Subject: **Comment Letter - BP 11133 Case Closure Summary**, Revised Notice of Opportunity for Public Comment; Underground Storage Tank Cleanup Fund Case Closure Recommendation; Claim Number 5502; Fuel Leak Case No. RO0000403; Global ID # T0600100210; BP #11133, 2220 98th Avenue, Oakland, CA 94603

Summary of ACEH's Review of the USTCF's UST Case Closure Summary

SWRCB Public Notification Map and List of Owners and Tenants

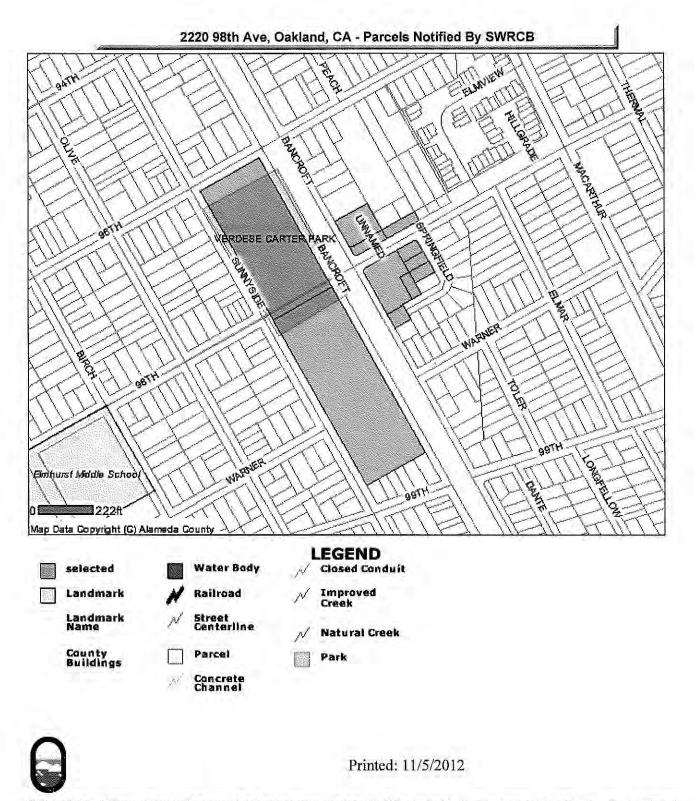
While the USTCF has made the UST Case Closure Summary available for public comment on the SWRCB's website, it appears to have failed to notify in a timely basis all interested parties, *including all owners and occupant of property potentially impacted by the petroleum release*, as required by the LTCP, CCR Chapter 16, and Chapter 6.7 of the H&SC. According to the LTCP Notification Requirements "municipal and county water districts, water replenishment districts, special act districts with groundwater management authority, agencies with authority to issue building permits for land affected by the petroleum release, and owners and occupants of all parcels adjacent to the impacted property shall be notified of the proposed case closure and provided a 60 day period to comment. The regulatory agency shall consider any comments when determining if the case should be closed or if site specific conditions warrant otherwise."

Further, it appears the USTCF has not conducted public notification requirements in accordance with the SWRCB and Regional Water Quality Control Boards April 2005 guidance document entitled *Final Draft Public Participation at Cleanup Sites*. According to this document "the level of public participation effort at a particular site should be based on the site's threat (to human health, water quality, and the environment), the degree of public concern or interest in site cleanup, and any environmental justice factors associated with the site. There may be more public concern or interest about a site when: contaminants have migrated or are likely to migrate off-site...".

The USTCF's *Revised Notice of Opportunity for Public Comment*, dated September 10, 2012, states that "a copy of the *Case Closure Summary* has been provided to the owner/operator, environmental consultant of record, the local agency that has been overseeing corrective action, the local water purveyor, and the water district specified by H&SC section 25299.39.2 subdivision (a)(1)." Concerned by this limited list of parties, ACEH contacted the USTCF and requested the list of recipients that the *Revised Notice of Opportunity for Public Comment* was sent to. Our review of the list of recipients (received by ACEH on October 22, 2012) indicates a lack of notification of many of the owners and residents of surrounding properties potentially affected by off-site migration of free product, contaminated groundwater, and/or soil gas, including residents of parcels owned by the Oakland Housing Authority. The Ms. Jeanine Townsend RO0000403 November 5, 2012, Page 4

USTCF's list of recipients and an appropriate public notification area map and a list of owners and tenants identified by ACEH's search of the County of Alameda Assessor's Office Property Value System who should receive notification of the USTCF's recommendation for case closure is provided as attachments to this response letter.
